Determination 2015/034

Regarding the authority's exercise of its powers of decision in refusing to issue a code compliance certificate for a 1-year-old house with profiled metal roof cladding at 8 The Drive, Twizel

Figure 1: Roof plan (not to scale)

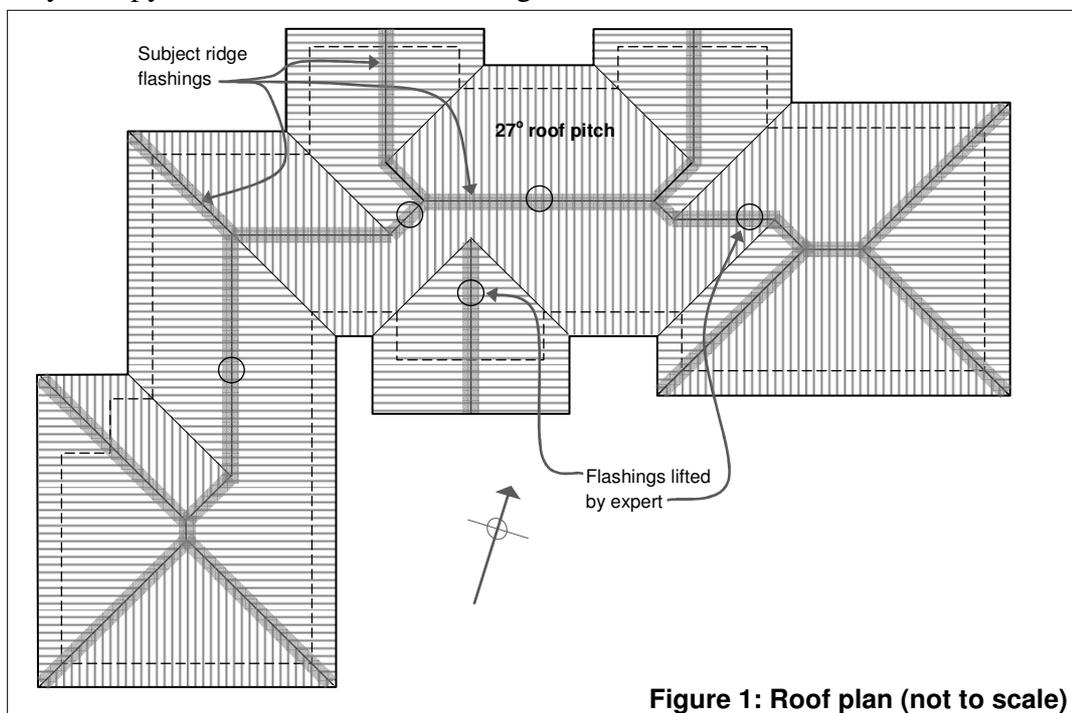
5.3.1 In order to investigate the underlying construction, the expert raised the ridge flashing at five locations (see Figure 1), and noted that in each location:

- no stop ends are installed to the top of the sheets
- no compressible seals are installed under the flashing
- the sheets carry up to the apex, with only a nominal gap, therefore increasing the effective cover of the ridge flashing

- there was no visual evidence of moisture tracks under the flashing, with a layer of fine dust apparent on the roofing surface.

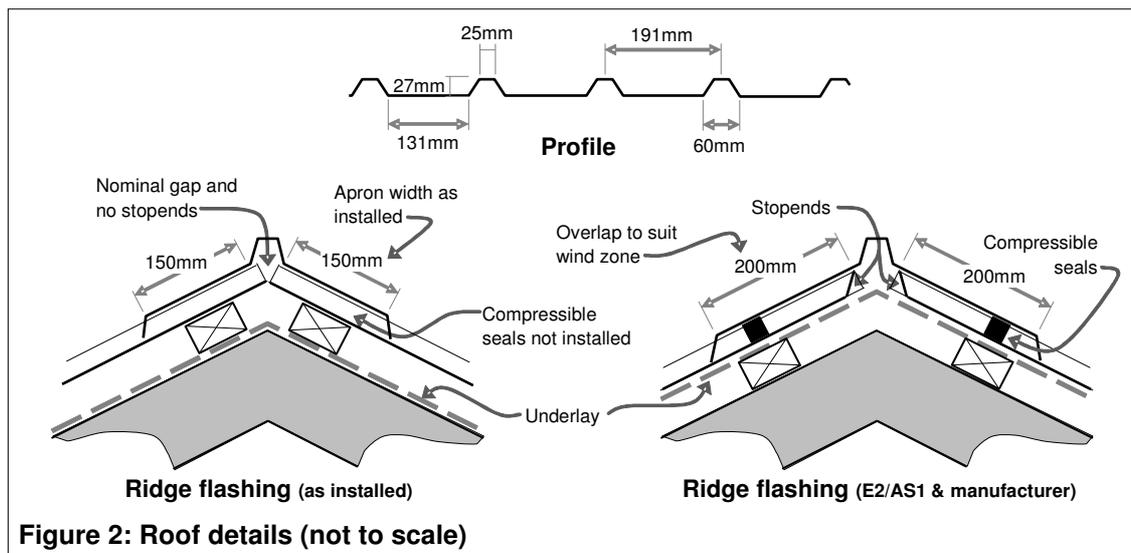
2.3.4 The expert investigated underlying construction at the roof ridges (see paragraph 5.3.1). As shown in Figure 2, the installed ridges include:

- installed flashings with aprons of about 150mm
- the tops of roofing sheets extended to almost meet at the apex
- no stop ends to the top of roof sheets
- no compressible seals installed between the flashing and the roofing
- roofing underlay wrapped over the ridge.

5.2.2 The expert discussed the situation with the owner who understood that the reduced width of the ridge flashing had resulted from the positioning of the top purlins (see Figure 2). The owner had been assured that the roofer 'had taken the roofing sheets right up to the apex line with only a nominal gap and that stop end turn-ups had been formed along with the building paper being carried over the ridge line'.

According to E2/AS1 and manufacturer (see Figure 2)	The installed ridge flashing system (see Figure 2)
Recommended ridge flashing details for the trapezoidal roof profile are appropriate for slopes down to 3°	The 27° pitch installed roof is well above the minimum, improving the shedding of water and the effectiveness of overlaps.
The aprons to ridge flashings should provide 200mm minimum overlap in very high wind zones	The installed ridge flashings are intended for lower wind zones, where a minimum overlap of 150mm is required.

According to E2/AS1 and manufacturer (see Figure 2)	The installed ridge flashing system (see Figure 2)
The manufacturer's ridge flashings allow for about 50mm gap between the top roof sheets at the apex	The roof sheets are installed with a nominal gap at the apex, so increasing the effective cover to about 175mm.
Compressible seals restrict any water that is driven under the ridge flashing	No compressible seals have been installed.
Sheet ends are turned up to restrict any water that may reach the tops of roofing from penetrating at the apex.	No stop ends have been installed to the tops of roofing sheets.
The roofing underlay is wrapped over the apex to allow any water that penetrates past the flashing to drain to the outside.	The underlay is wrapped over the apex to overlap beyond the ridge line

- stop ends were formed to provide an upstand height of 10mm minimum
- compressible seals were installed in accordance with manufacturer's details.

6.2.3 However the expert's investigations also identified significant omissions and I therefore consider the remedial work is necessary to the roof ridges in respect of:

- the lack of stop ends to the tops of the roofing sheets
- the lack of compressible seals between the ridge flashing and the roofing.
